April 11, 2019

To: Ridgeland WRF Expansion Plan Holders

Re: Addendum #1
Ridgeland WRF Expansion

SHEET NO.	OF
M803	---
FILE NO.	
1636.6

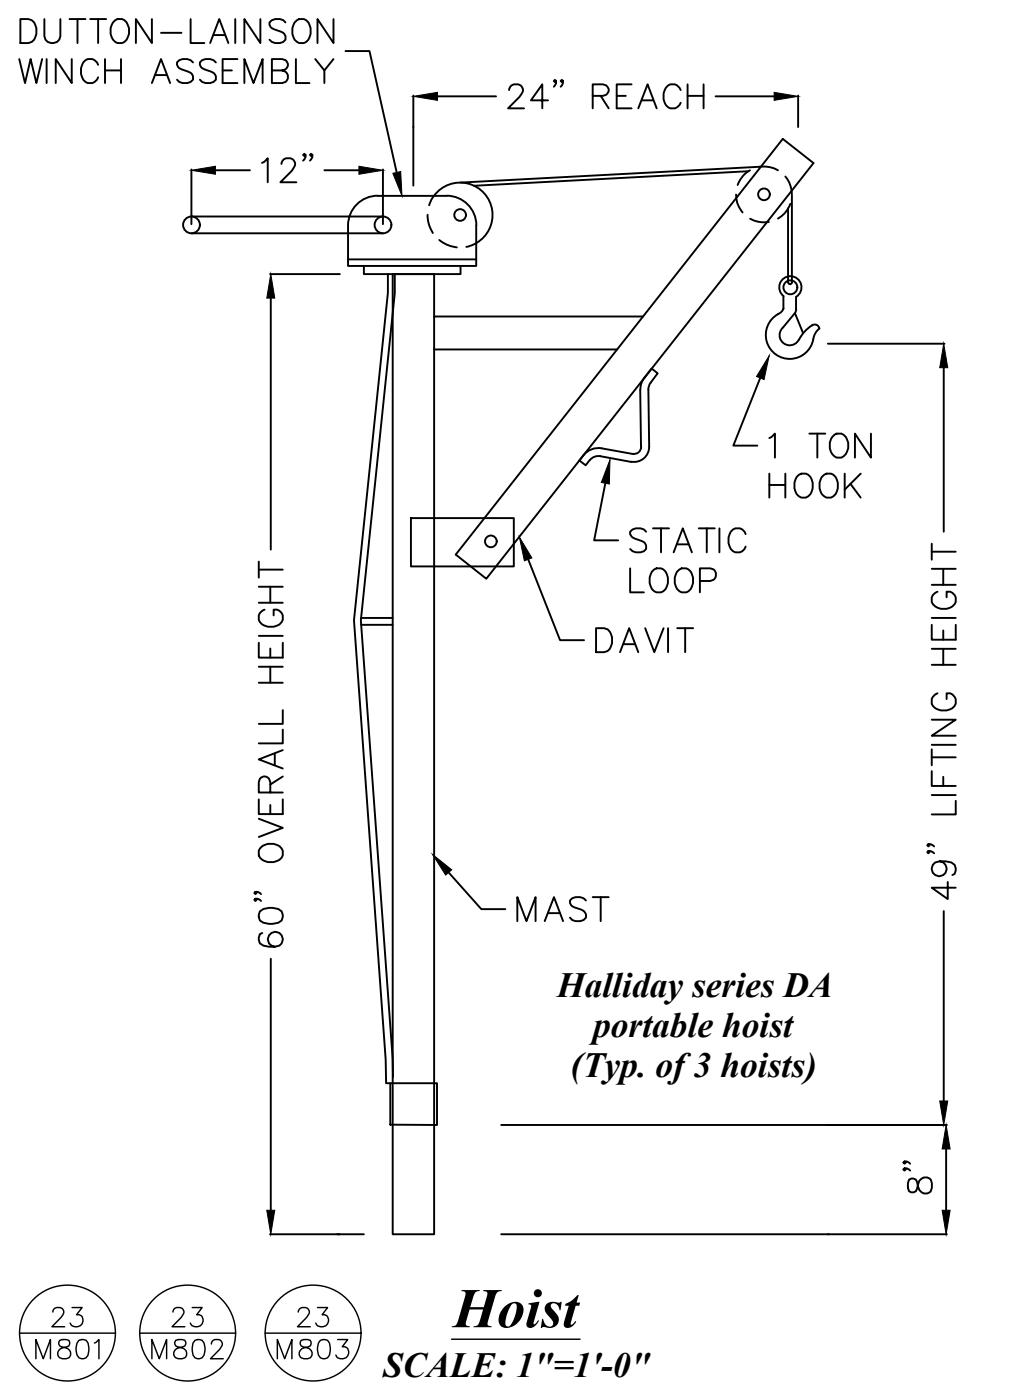
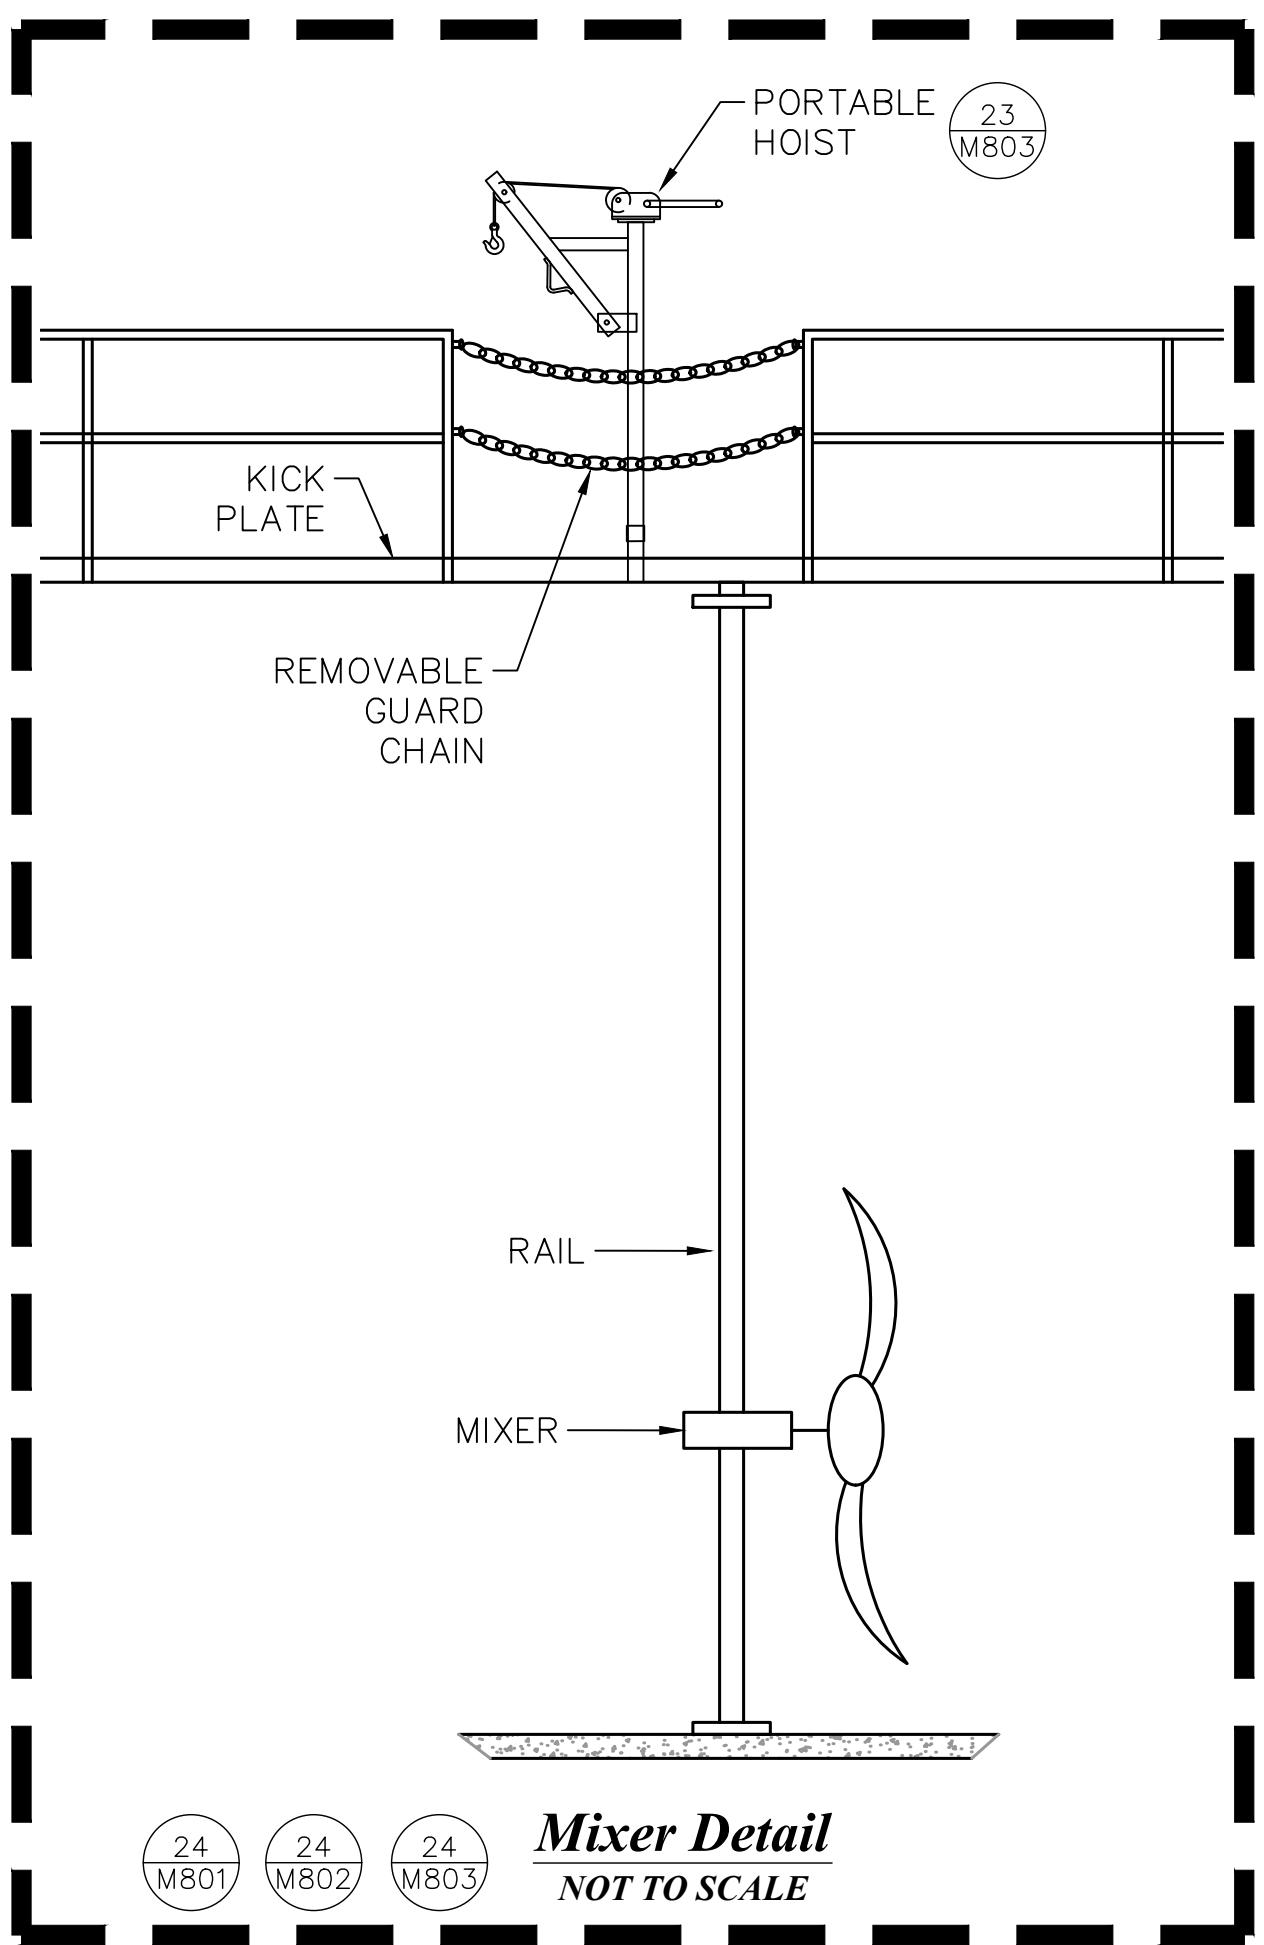
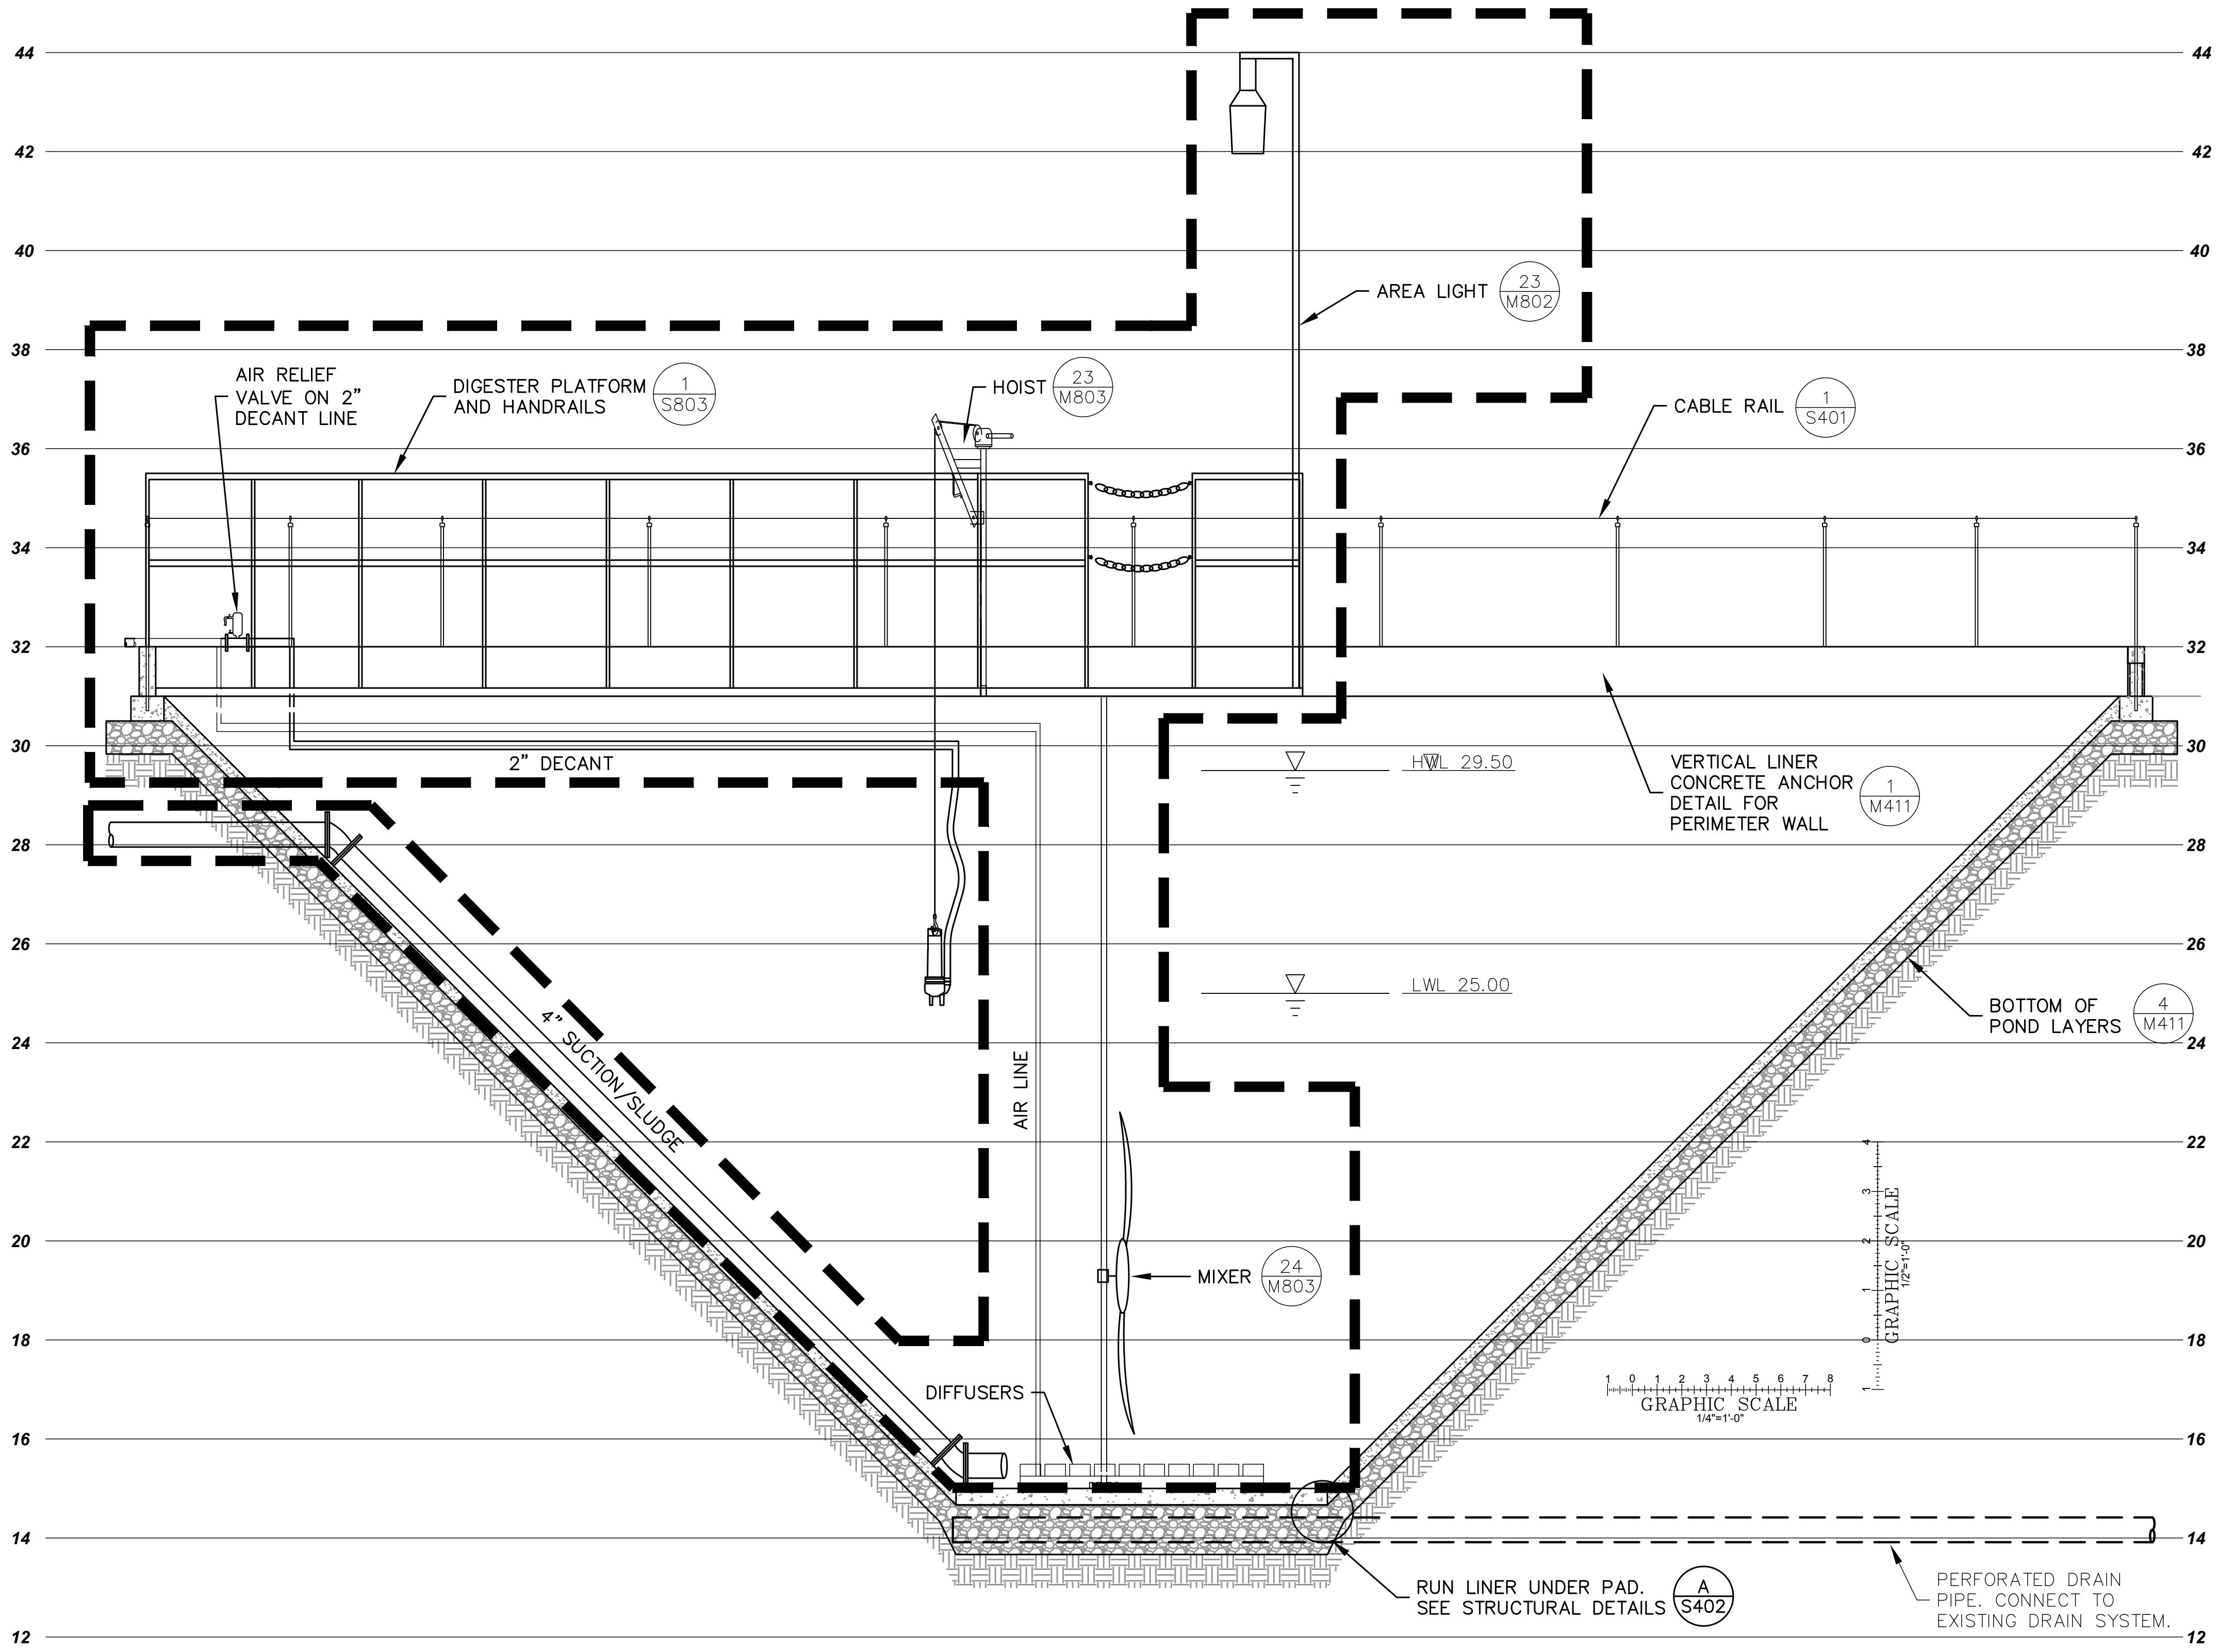
- 1.7 BASE BID: SLUDGE HOLDING POND, DECANT PUMP, AND PUMP HOIST.
- 1.8 SLUDGE SUCTION PIPE.

1 M811
POLYMER MAKEDOWN SYSTEM
PULSAFEEDER MANUAL CONTROL SYSTEM
PESMCEVSBONN-XXX
POLYMER OUTPUT 4-10 GPH, WITH STOP
5-10 GPH. USABB #62089

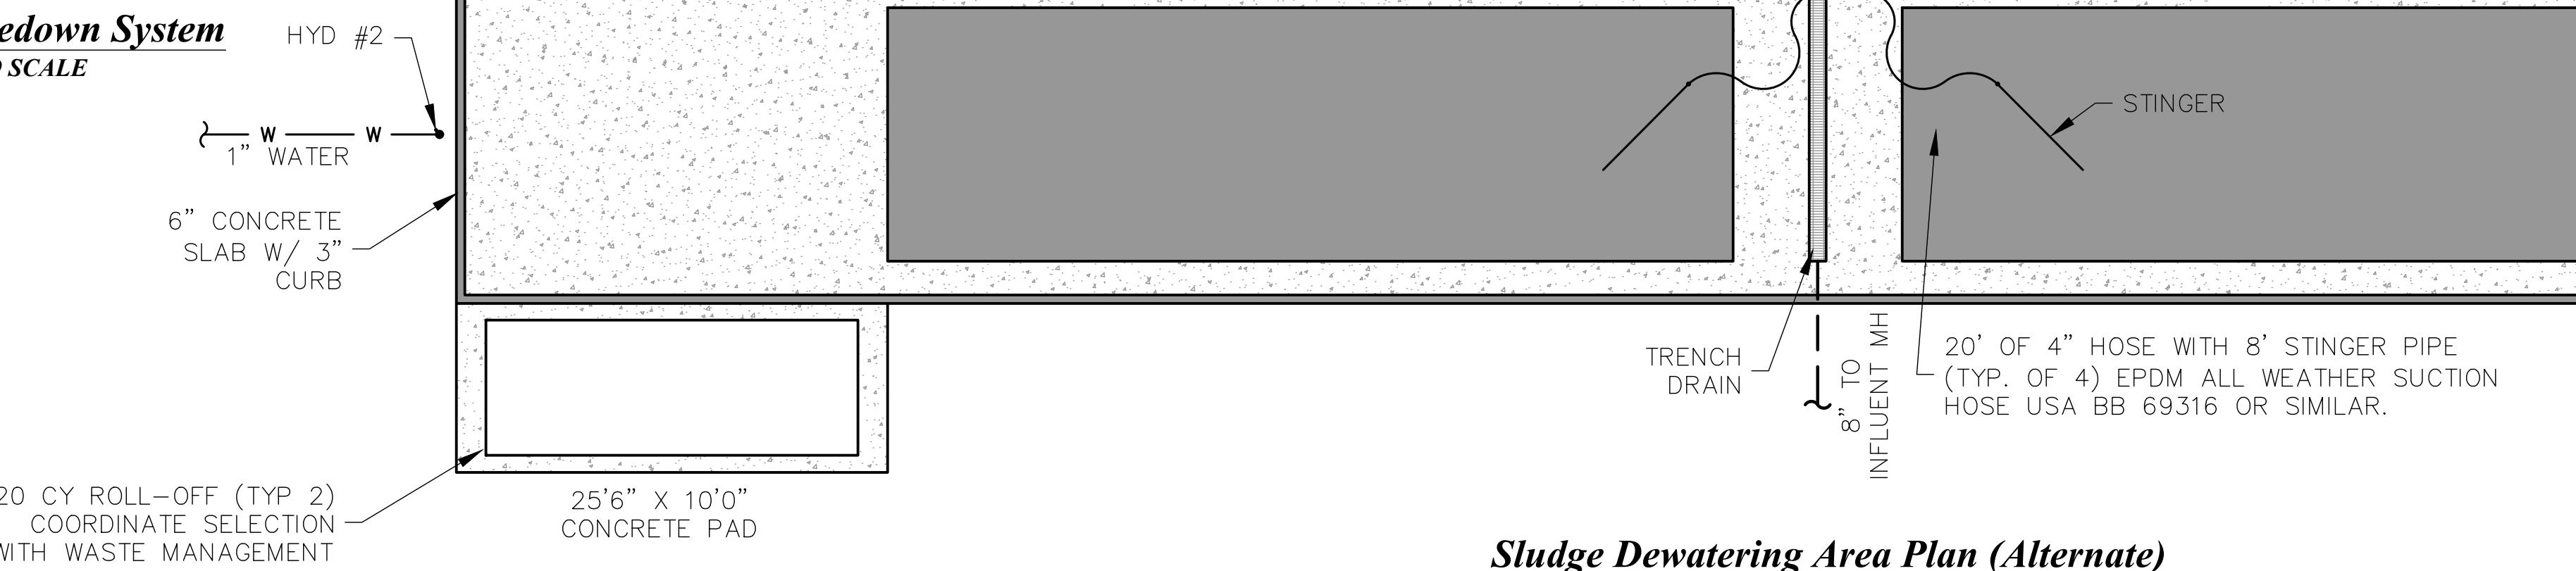
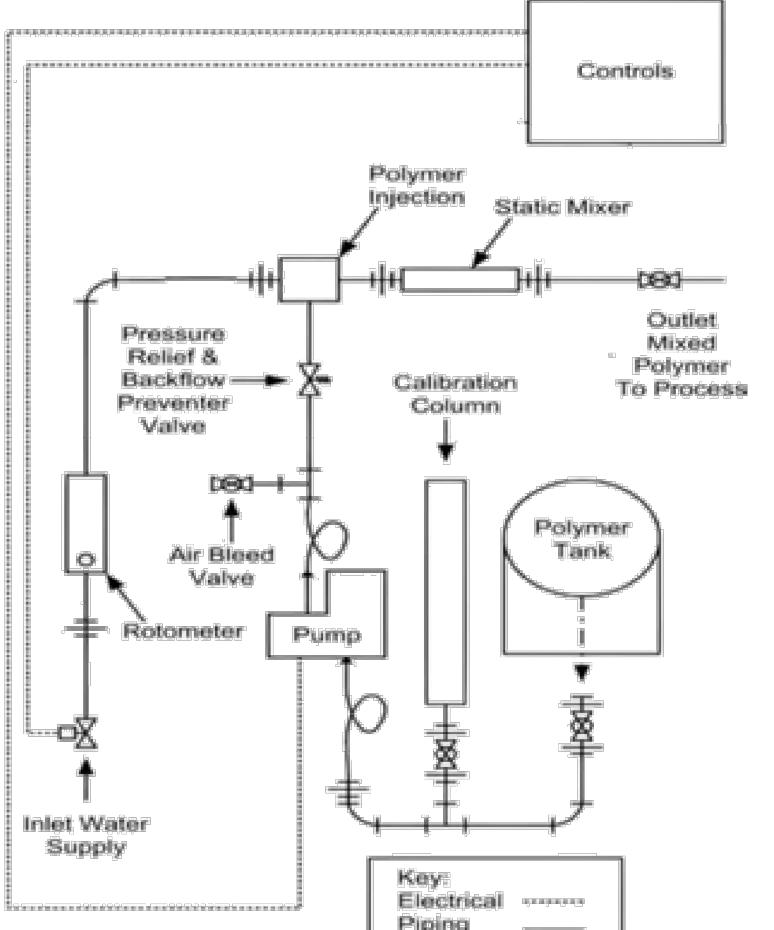
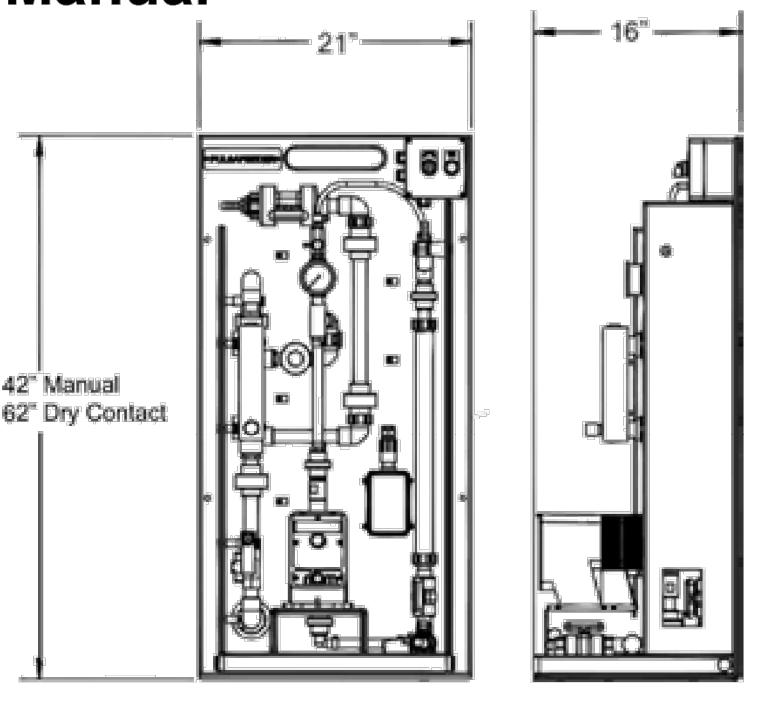
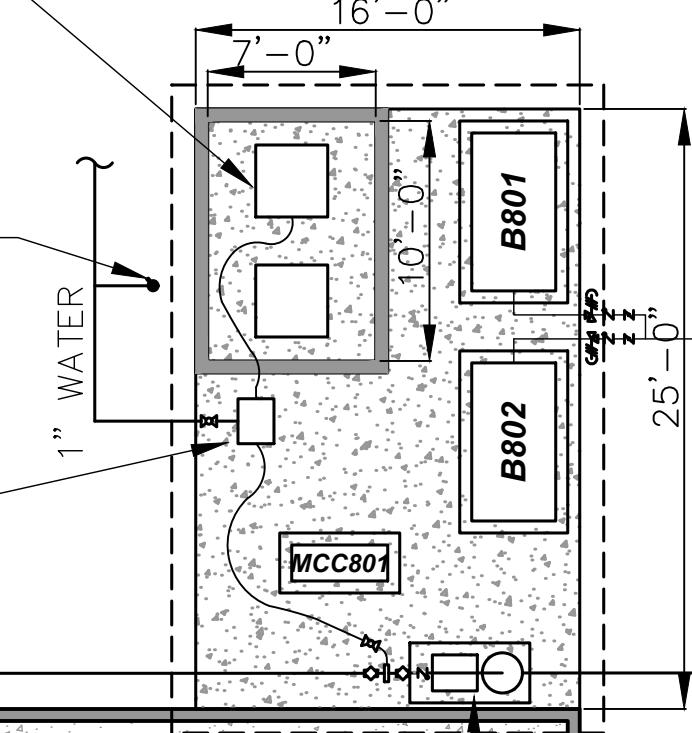
1.8	Sludge dewatering - G004 – Hyd profile, G012 – Demo, G022 – Phasing, ESC003, M800s, S800s, E002, E011, E012, CS014	<ol style="list-style-type: none"> The sludge dewatering area is being presented as an alternate. The storm drain piping is being modified.

1.8 GEOTUBES ALTERNATE
